Interactive comment on “Vulnerability of groundwater resources to interaction with river water in a boreal catchment” by A. Rautio et al.

A Author Comment.

The manuscript HESSD-2014-556 “Vulnerability of groundwater resources to interaction with river water in a boreal catchment” by A. Rautio, A.-L. Kivimäki, K. Korkka-Niemi, M. Nygård, V.-P. Salonen, K. Lahti, and H. Vahtera

Fig. 1.

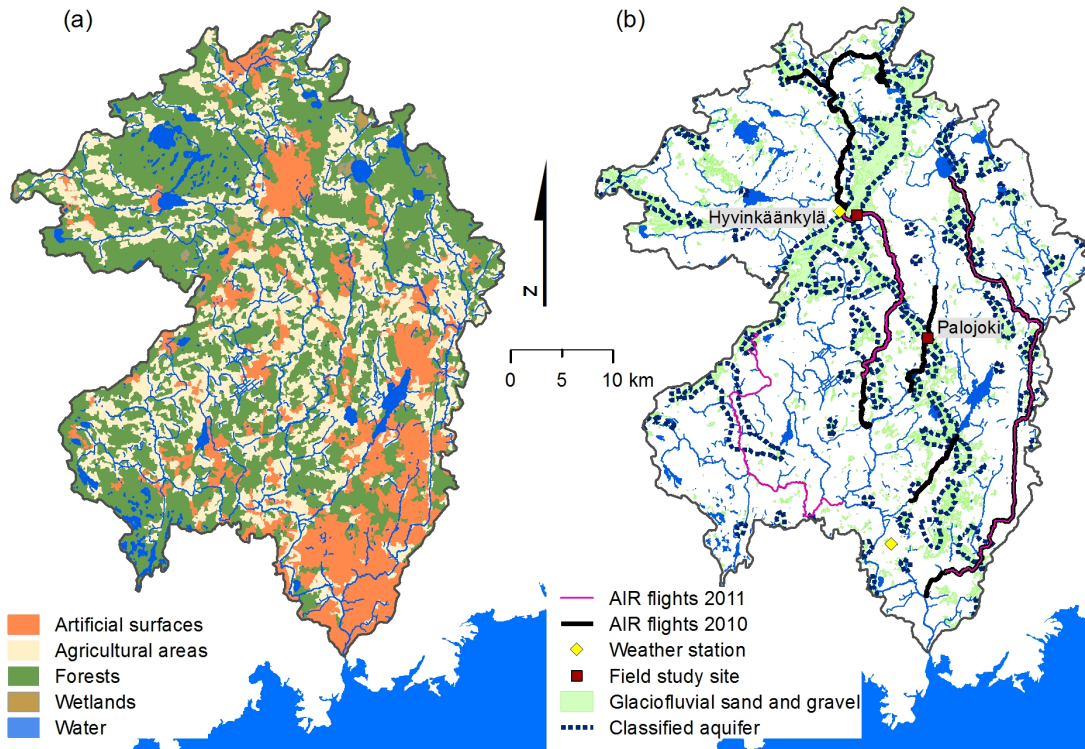
p. 2439, L. 21. Cover-moraine sheets and end-moraine ridges need to be explained in Figure 1a. These two geomorphological elements are not shown on the legend of Fig 1a ?

Fig1a. The legend is a mixture of lithological units and geomorphological units Fig 2b. Show the extension of the classified aquifers with a more pronounced signature. The dashed line used to outline the classified aquifers is difficult to see. I will suggest that

We have added references in the text followingly: bedrock terrain and glacial deposits forming cover-moraine sheets (glacial till in Fig. 1a) and end-moraine ridges (glaciofluvial sand and gravel in Fig. 1a) (Tikkanen, 1989) (Fig.1a).

Fig. 2.

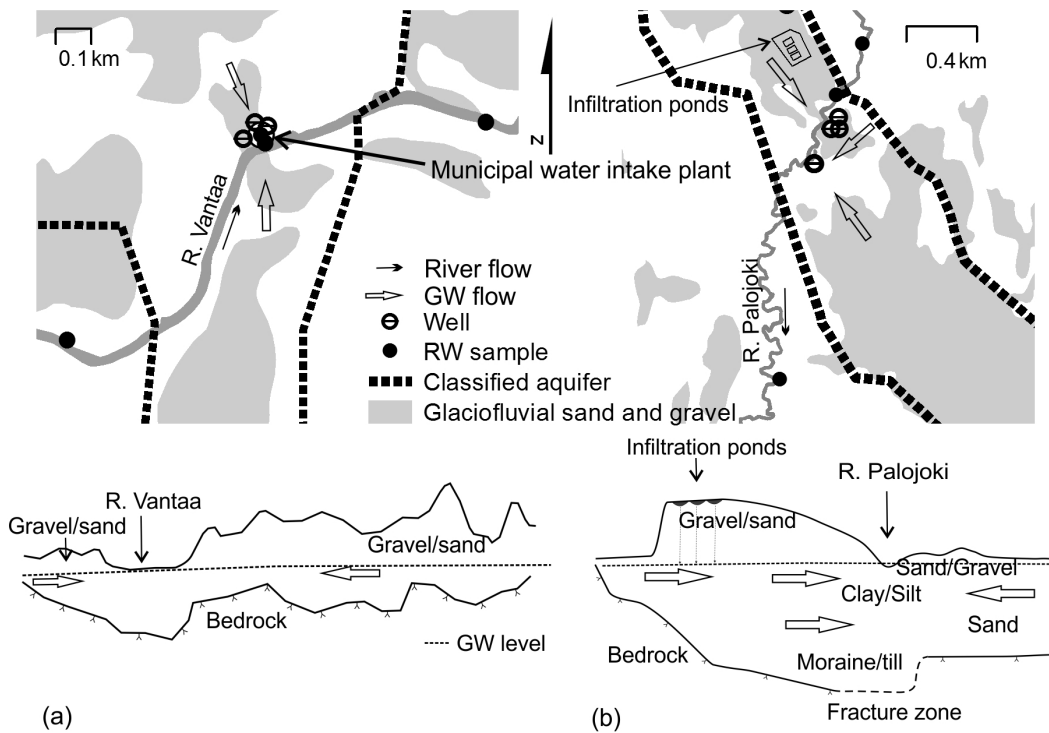
you use oblique hatching as you use in Korkka-Niemi et al (2012, Figure 1). Explain “classified aquifer” – not explained in text. In the legend: IR flights 2011 and IR flights 2012 should be changed to AIR flights 2011 and AIR flights 2012

The classified aquifers have been explained in figure caption of 2b. However, we have left the classified aquifer symbol in previous for as it is the official symbol used by Finnish environmental agencies. We have changed IR flights 2010 and IR flights 2011 to IR flights 2010 and AIR flights 2011.

Fig. 3.

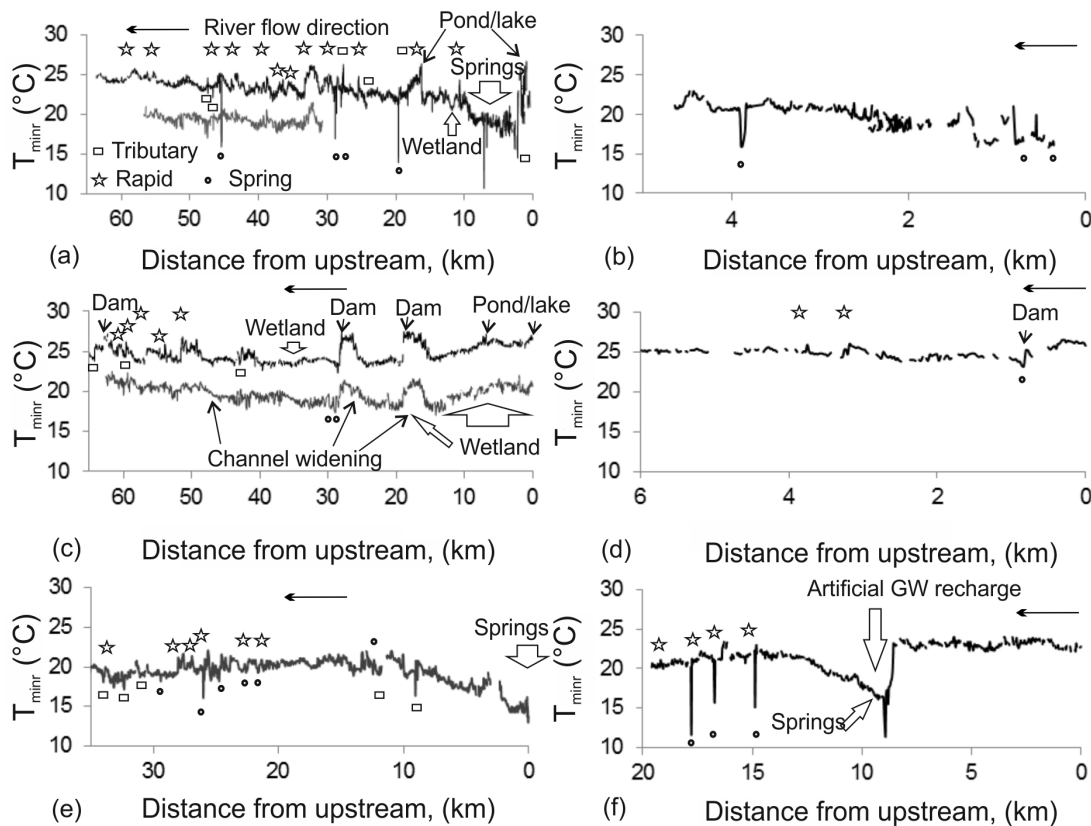
P. 2440, L. 25. Jäniksenlinna aquifer is not shown in fig 3b.

Fig 3. Indicate the area with the classified aquifers with another signature. It is impossible to see the position of the municipal intake plant and wells as they are grouped too close in Fig 3a and 3b.

The classified aquifer in Fig. 3b is Jäniksenlinna aquifer. We have added followingly: The recharge of natural GW in the shallow and unconfined Jäniksenlinna aquifer is approximately 4000 m³ d⁻¹ (Hatva, 1989) (classified aquifer in Fig. 3b).

We have left the symbol in previous form. Unfortunately, production well are close to each other and the municipal water intake plant well symbol is covered by them. We have added arrow to pointed out the location of intake plant.
